**Proposed Indoor Child Play Centre
(Leisure and Recreation)**

PLANNING REPORT

Planning Permit Application Number: PP2024-0233 Development and use of Child Play Centre (Leisure & Recreation) 191-201 Morriss Rd WARRNAMBOOL VIC 3280

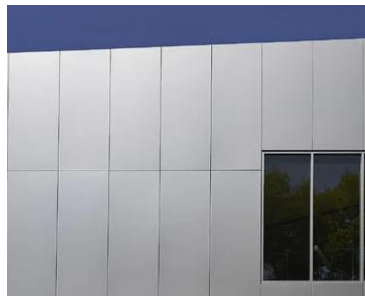
3. Provide a colours and material schedule.

The predominate colour proposed is Colourbond Surf Mist and there will be some Highlight contrasting trim colours in tones of grey such as Colourbond Basalt.

As noted on the plans

Walls to 3m Concrete Tilt Slab Painted
Walls above 3m Side and Rear Colourbond Steel
Walls above 3m Front and Part Sides Flat Panel
Frame Structural Steel insulated Roof and Walls
Roof Steel

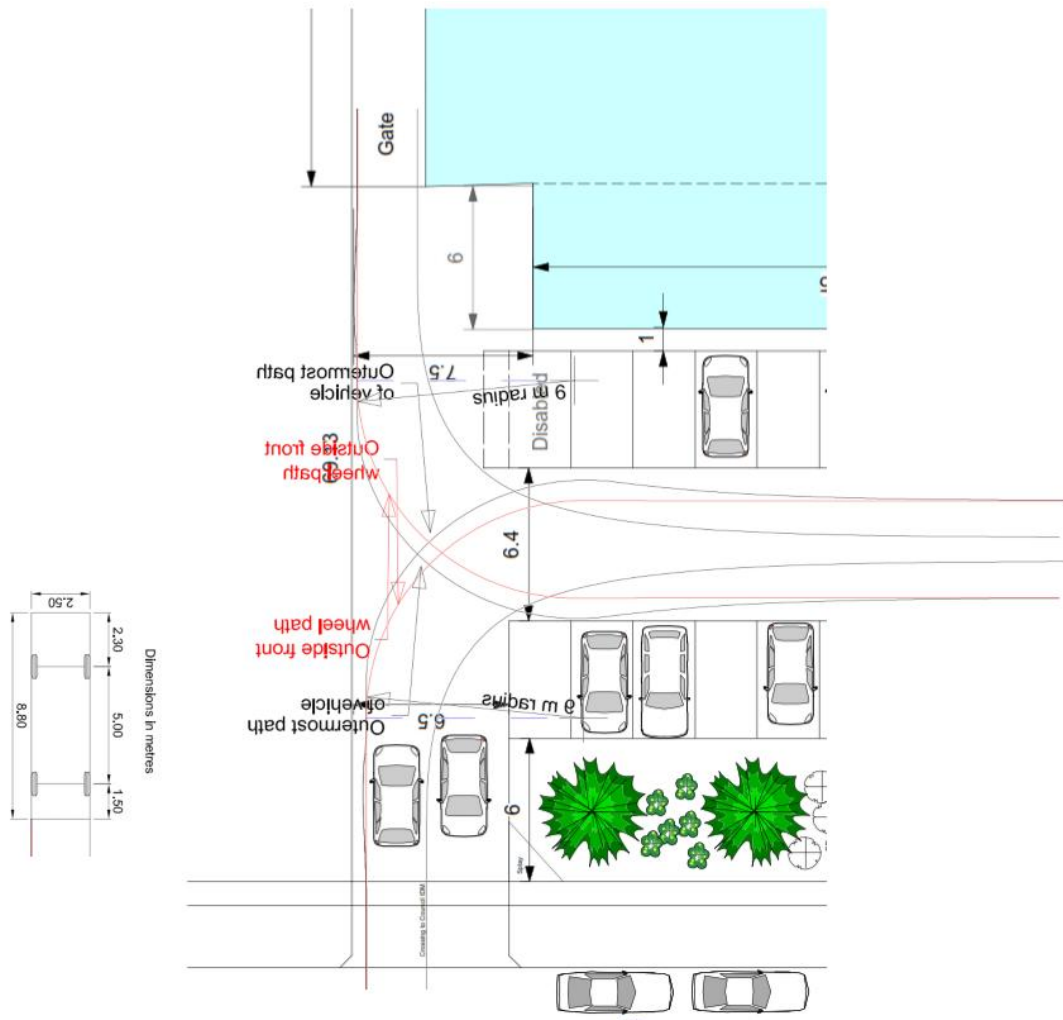
4. Provide details in relation to the proposed use including but not limited to patron numbers, hours of operation, staff numbers etc.

As noted on the Plans and in the Report the number of patrons will be up to 80 persons mainly on weekends and school holidays. Staff numbers 2 to 3. The Hours proposed are Mon-Thu: 9am-3pm, Fri: 9am-6pm, Sat and Sun: 9am-4pm. Some cleaning, administrative and maintenance activities will occur outside these hours. Deliveries will only occur outside these hours for safety reasons. Deliveries will not involve large trucks.

The building will contain a multi-level play structure as follows:
